LILLIE B. DAY CARE SUBDIVISION

APPLICATION NUMBER 15 DATE April 17, 2003
APPLICANT Lillie B. Day Care Subdivision
REQUEST Subdivision

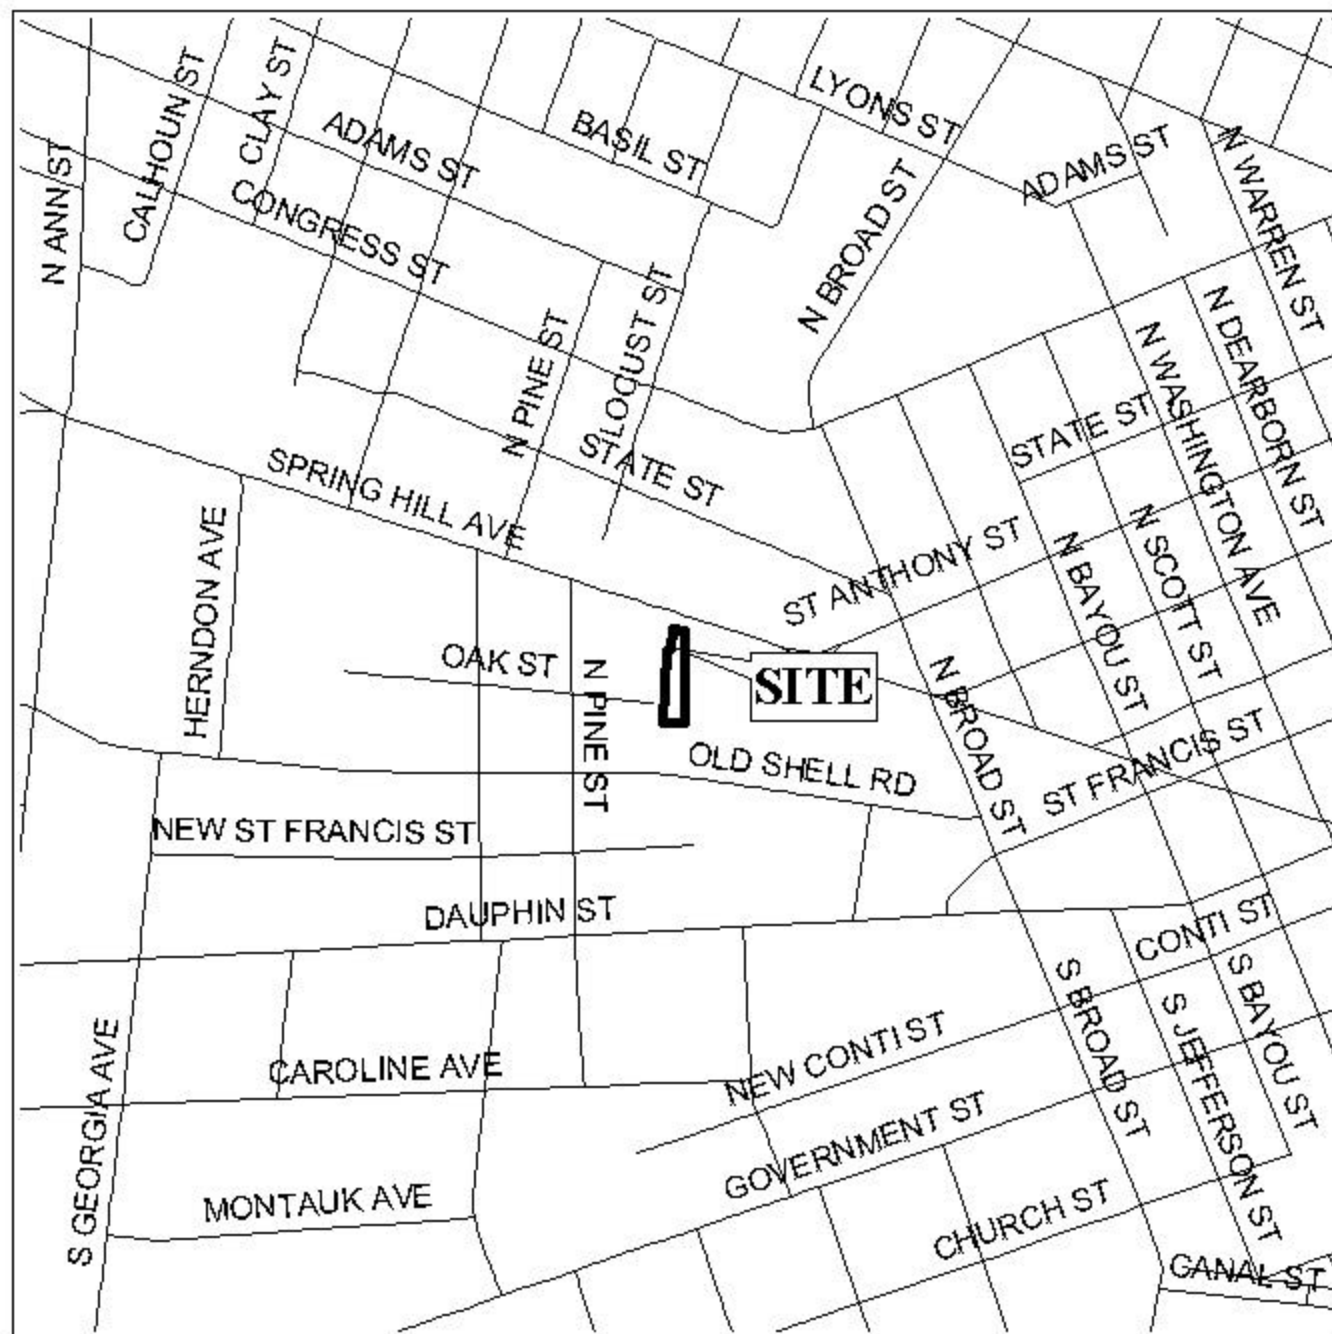
Spring Hill Avenue, which is a planned major street, has an existing right-of-way in compliance with the Major Street Plan. With the site being located on a major street, access management is a concern; therefore the placement of a note on the final plat stating that the site is limited to one curb cut to Spring Hill Avenue with the location and design to be approved by Traffic Engineering would be appropriate.

As illustrated on the plat, the site is adjacent to and has accesses via a ten-foot wide alley. The staff conducted research to determine if the alley is recognized or maintained by the city. The research indicated that the city does not recognize or maintain the 10-foot wide alley; therefore, the placement of a note on the final plat stating the site is denied access alley or the submission of an Administrative PUD to allow for shared access, should be required

As illustrated on the Vicinity Map, there are existing structures on the property to the west that encroach into the side yard setback; however, these structures are “non-conforming” and thus have no bearing on the proposed subdivision.

As this site being zoned commercially, a buffer in compliance with Section V.A.7 of the Subdivision Regulations should be required where the site adjoins residential property.

The twenty-five foot minimum building setback line is not shown but would be required on the final plat.

The plat meets the minimum requirements of the Subdivision Regulations and is recommended for Tentative Approval subject to the following conditions: 1) the placement of a note on the final plat stating that the site is limited to one curb cut to Spring Hill Avenue with the location and design to be approved by Traffic Engineering; 2) the placement of a note on the final plat stating the site is denied access to the alley or the submission of an Administrative PUD to allow for shared access; 3) the provision of a buffer in compliance with Section V.A.7 of the Subdivision Regulations should be required where the site adjoins residential property; and 4) the placement of the twenty-five foot minimum building setback line on the final plat.
